Ordinary Council Meeting - 22 August 2023 Attachments

4.1 DA2023/00055 - 1100 COLES BAY RD, COLES BAY - VISITOR ACCOMMODATION, CAFE, CELLAR	
DOOR AND DWELLING.....	2
4.1.1 Revised Plans - DA 2023/00055.....	2

PROPOSED RESIDENCE, CABINS AND CELLAR DOOR 1100 COLES BAY ROAD COLES BAY

DRAWING: ELEVATIONS		DESIGNER SH	DRAWN SH
B	ISSUED FOR DA WITH FAMILY CABIN ADDED		30/05/23
A	ISSUED FOR DA		05/03/23
REV.	DESCRIPTION	DATE	
CLIENT: ROBERT & KIM ALFELDI			
SITE ADDRESS 1100 COLES BAY ROAD, COLES BAY, 7215			
Date: 29/10/2022	Project # 221001	Scale: 1:100 @ A3	Sheet # A051

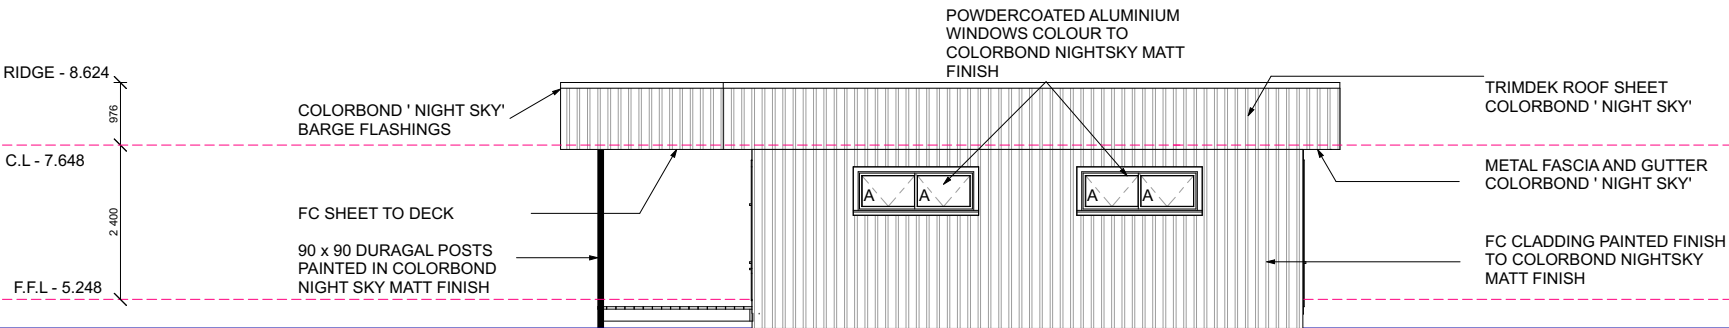
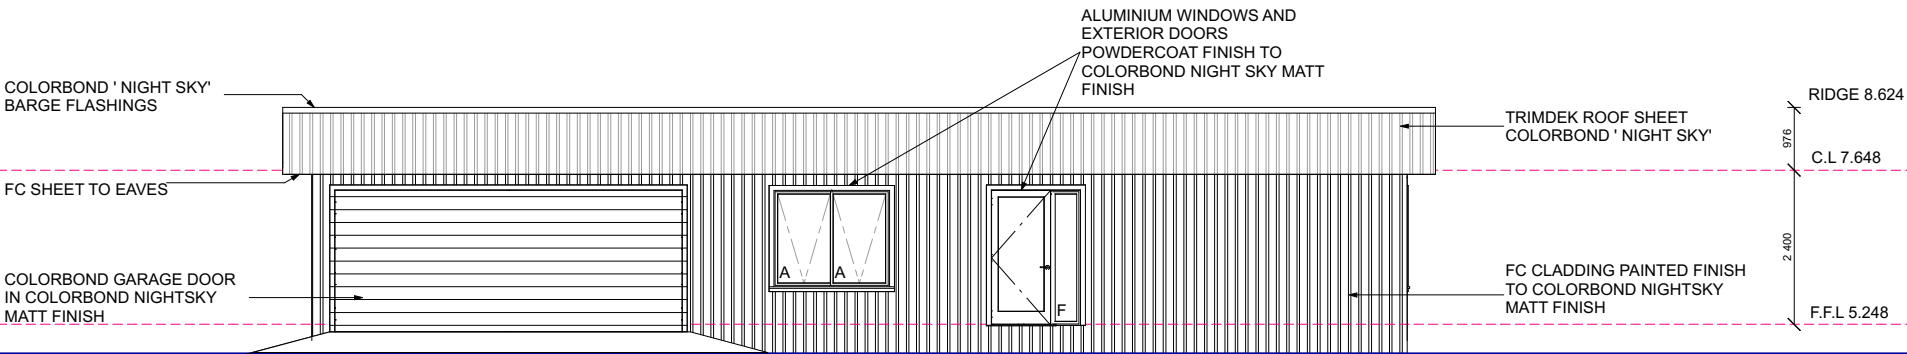
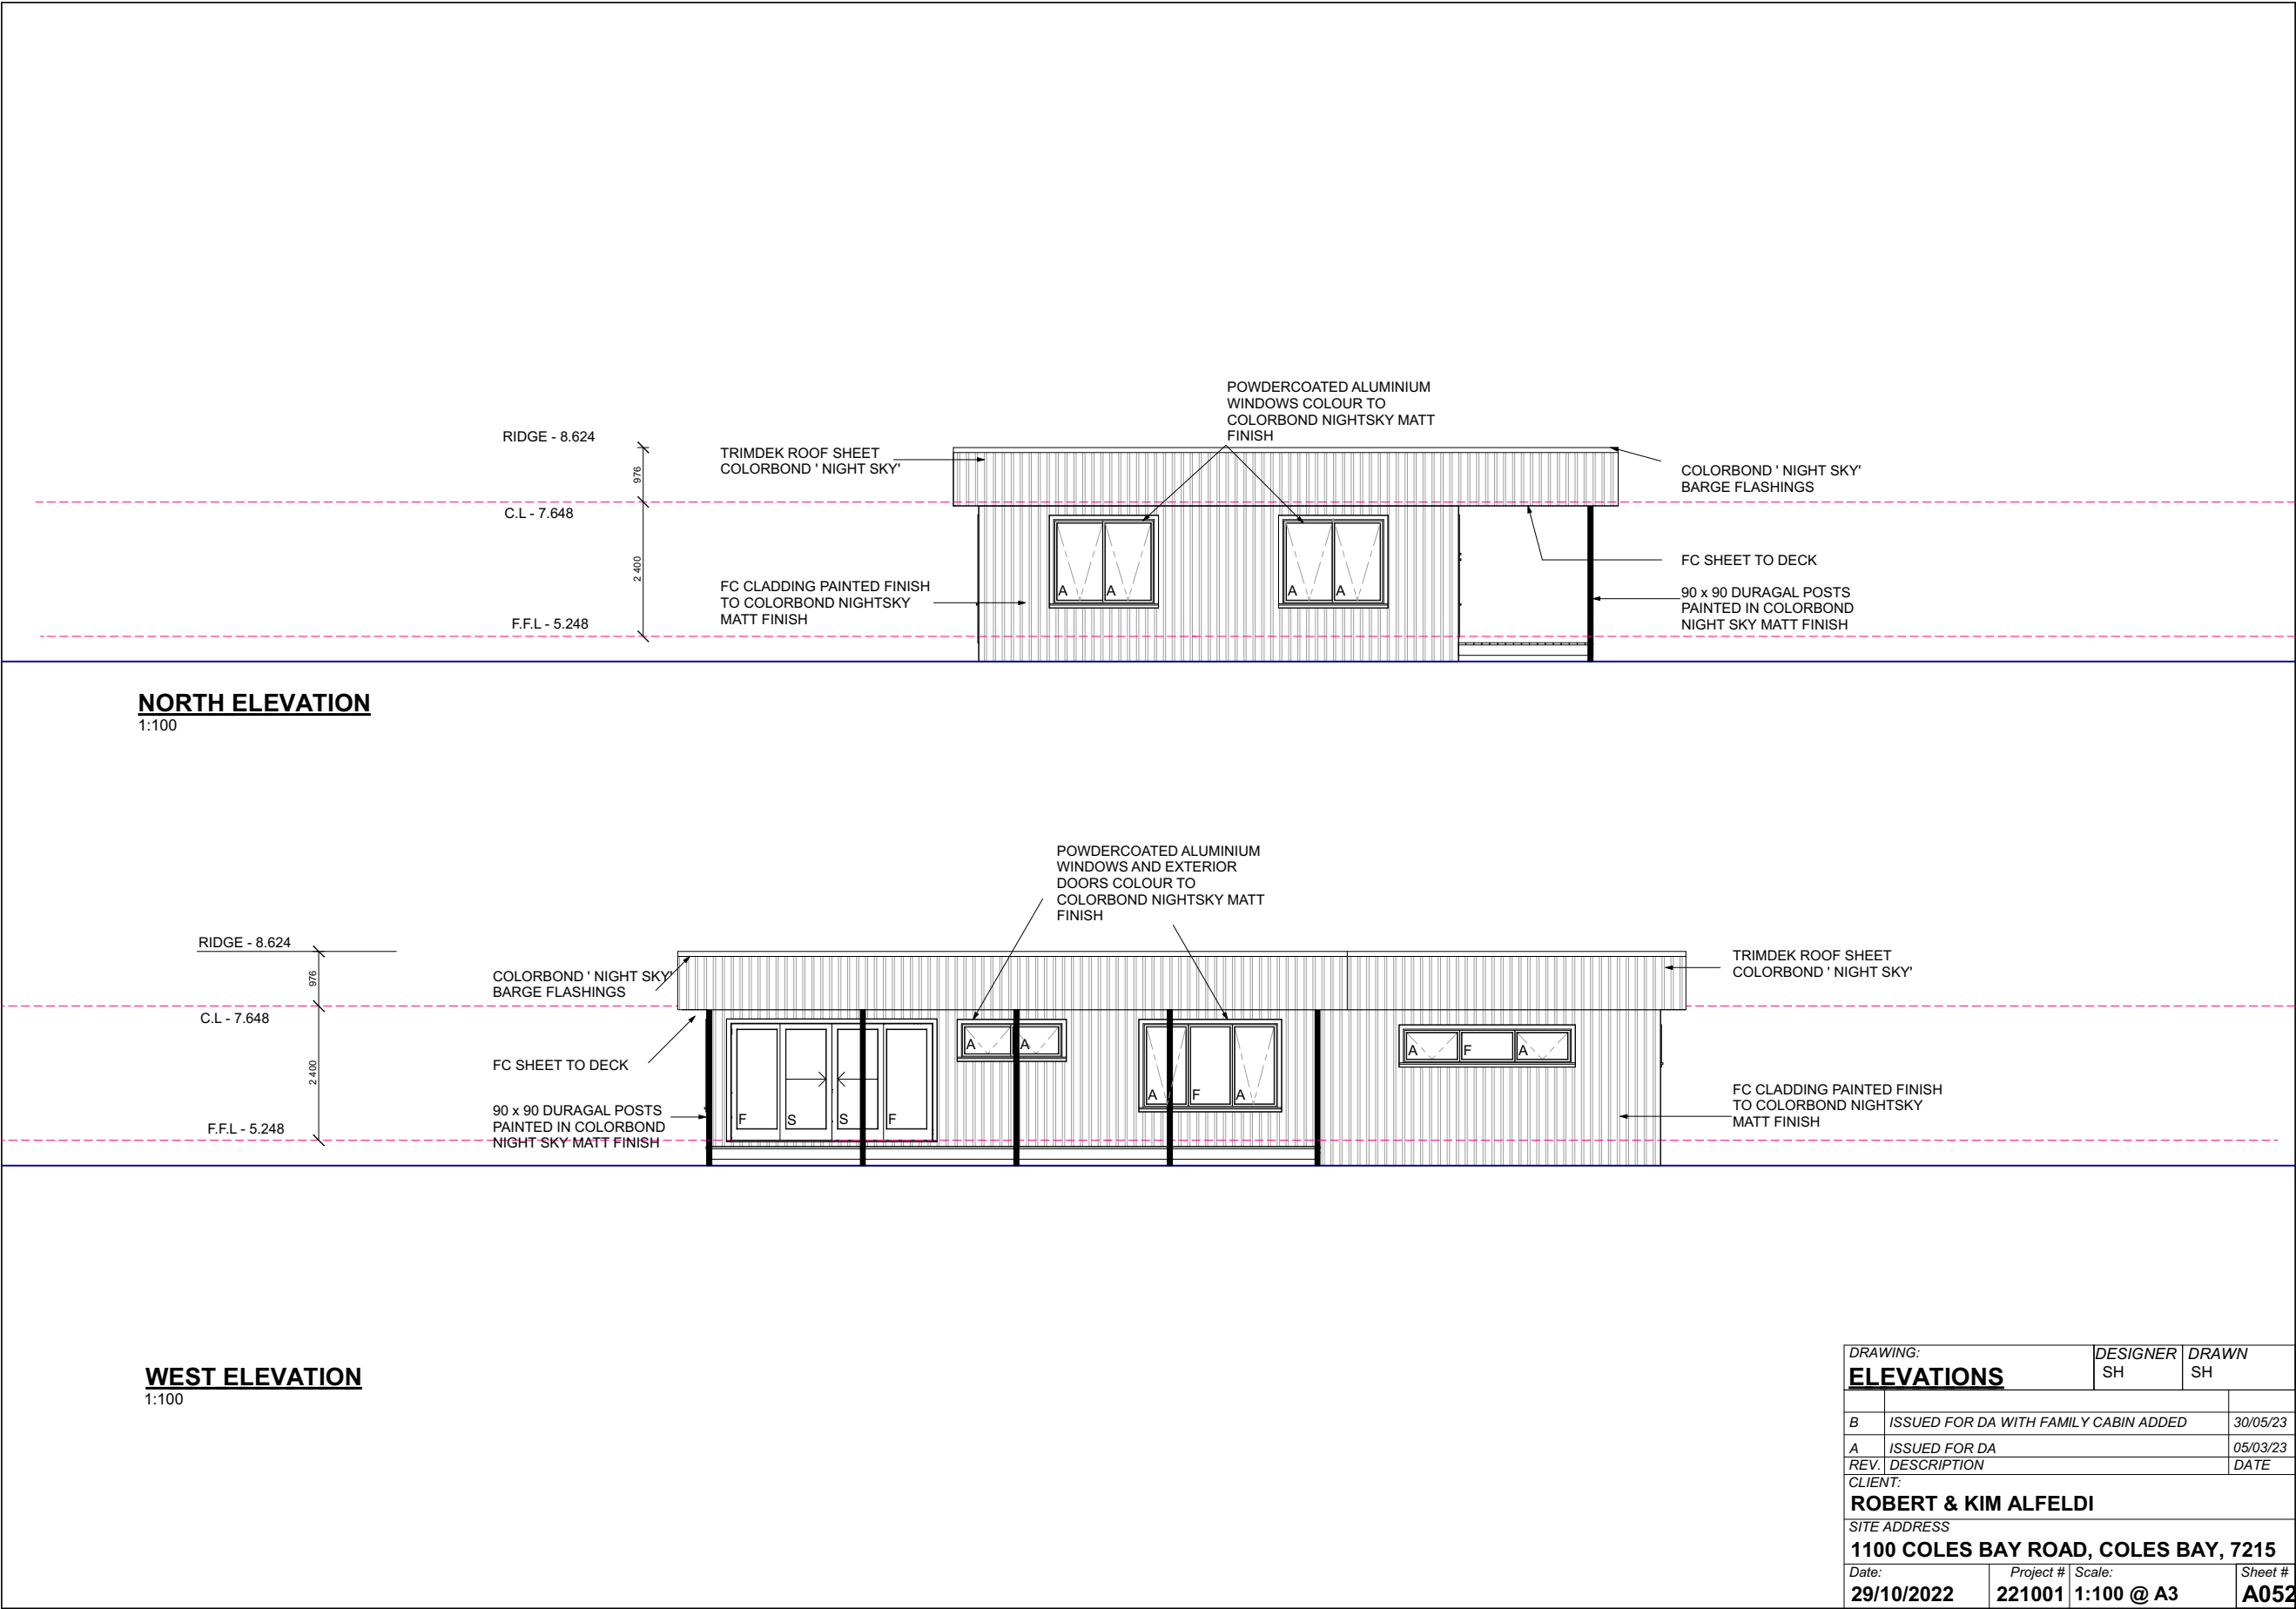
It is noted that the application has considered reflectance and colour in the response to the Scenic Protection Corridor and has included annotations with low-reflectance colours in the "Elevations" Sheet A051-052, plans supplied.

Figure 4.1 – Proposed 8*1 Bedroom Cabins and driveway.

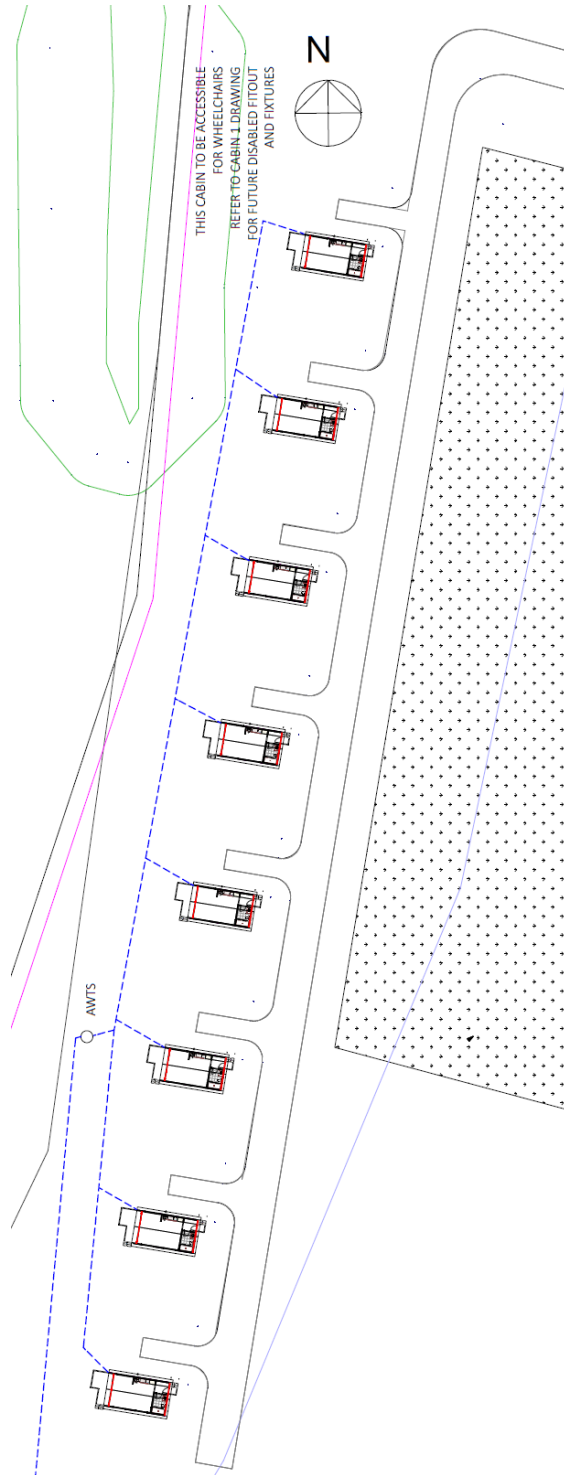
From assessment of the vegetation on the sight line and bend in Coles Bay on the Southern approach to the property access, see Figure 14, mitigation of the situation by increasing available sight distance with vegetation clearing (removing / pruning trees and bushes) is proposed to improve traffic safety for North Bound traffic approaching the access. Accordingly a BAL is not required.

- Access works permit to undertake the required works in the State Road reservation:
 - mitigation of available sight distance with vegetation clearing (removing / pruning trees and bushes) considering the bend in Coles Bay Road on the Southern approach to the property access, see Figure 14,
 - provision of BAR before Stage 3.
